UNITED STATES PATENT AND TRADEMARK OFFICE

APPLICATION NO.	FILING DATE	FIRST NAMED INVENTOR	ATTORNEY DOCKET NO.	CONFIRMATION NO.
09/894,787	06/28/2001	In Kap Kim	ORIEN22.001AUS	5977

Office Action Summary

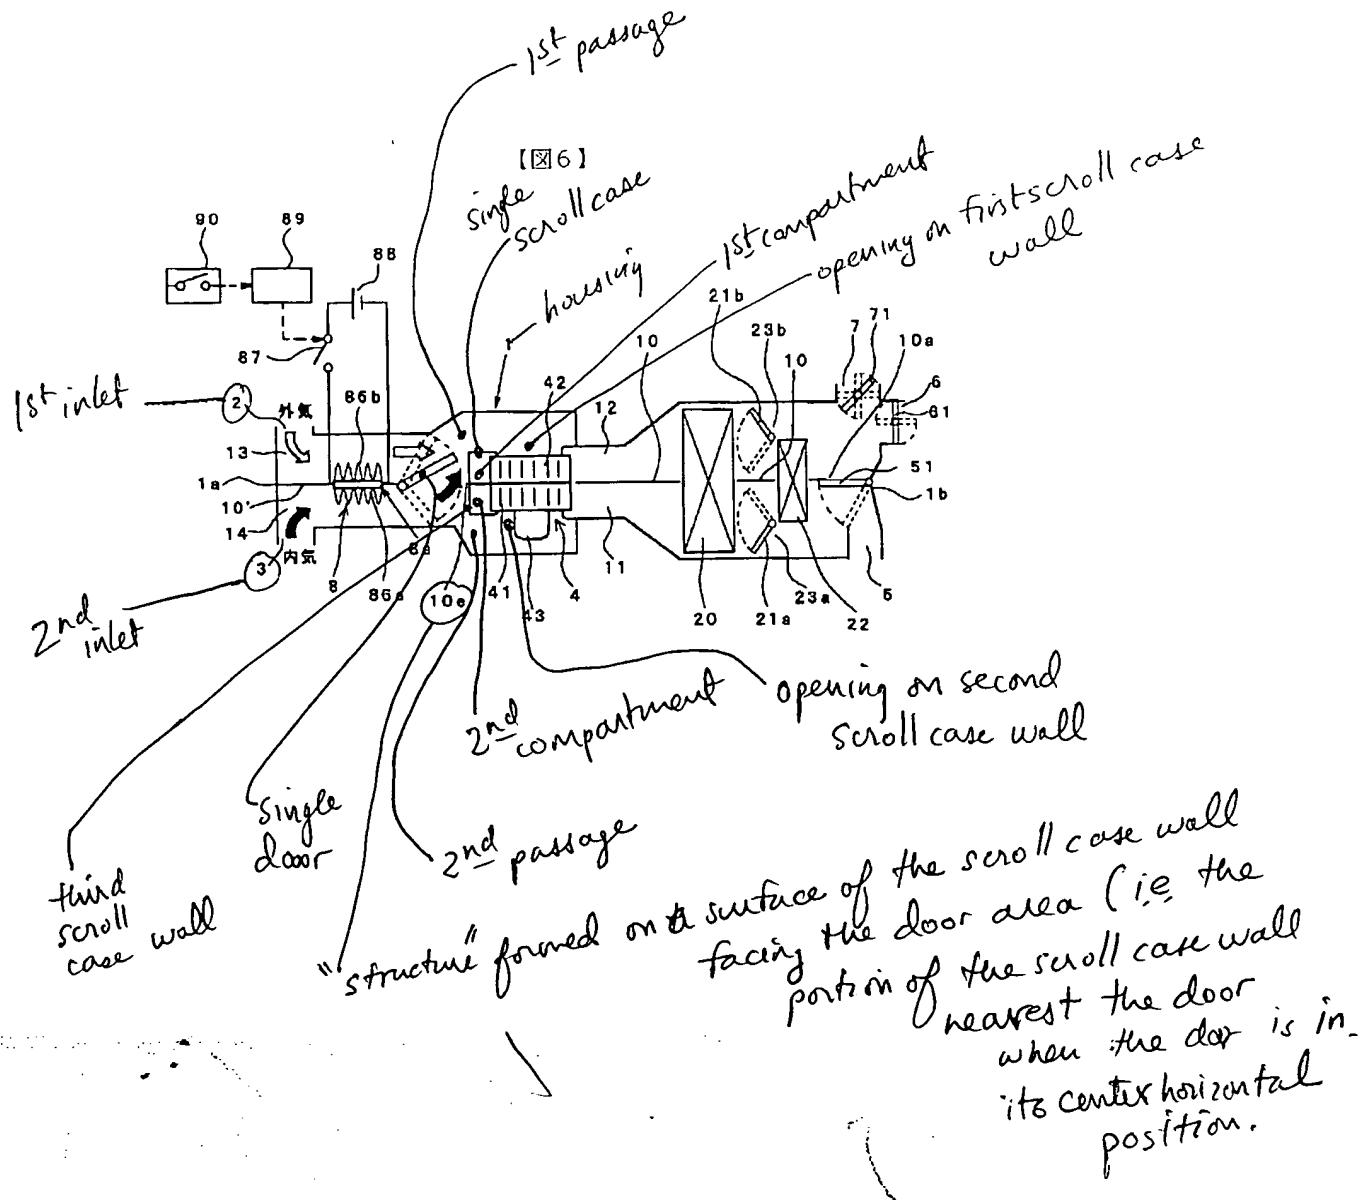
Claims 12-17 and 20-26 are rejected under 35 U.S.C. 102(b) as being anticipated by JP 9-254630.

See Figure 6 below. The "structure" recitation of claim 12 can, by applicant's disclosure, be a wall 27 (Figure 2) or a notch 27 (Figure 9). In the Examiner's reading of JP 9-254360, the "structure" recitation of claim 12 is met by the portion of the fan scroll casing that it at the terminal end of the lead line denoted 10e (i.e. the portion of the scroll case wall nearest the door when the door is in its center horizontal position)

Figure 9 F JP 60-8105
w/ fan of JP 09-024723
substituted.

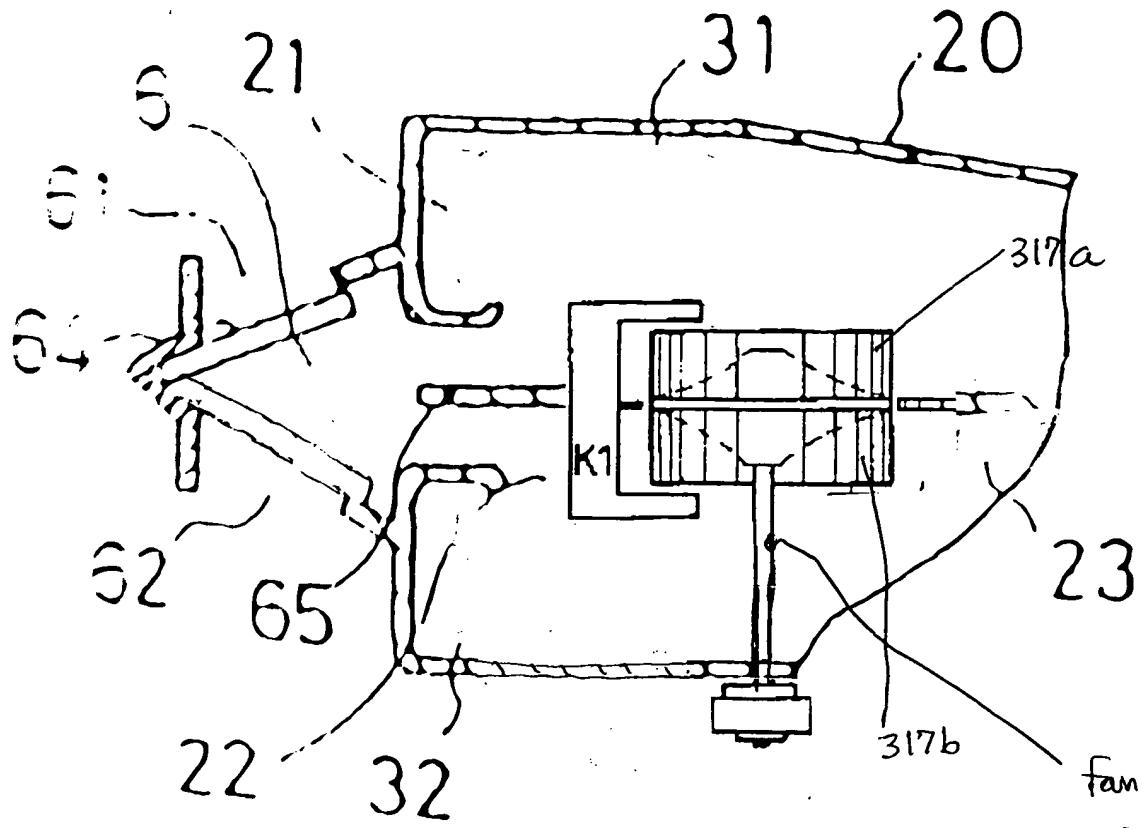
Claims 12-18 and 20-31 are rejected under 35 U.S.C. 103(a) as being unpatentable over the combined teachings of JP 60-8105 (Figure 9) and JP 09-024723 (Figure 13).

To have replaced the spaced apart blowers 31 and 32 of JP '105 (Figure 9) with a single scroll blower with two blowers 317a and 317b mounted together would have been obvious. See illustration below.

fan from Figure 13
of JP 09-024723
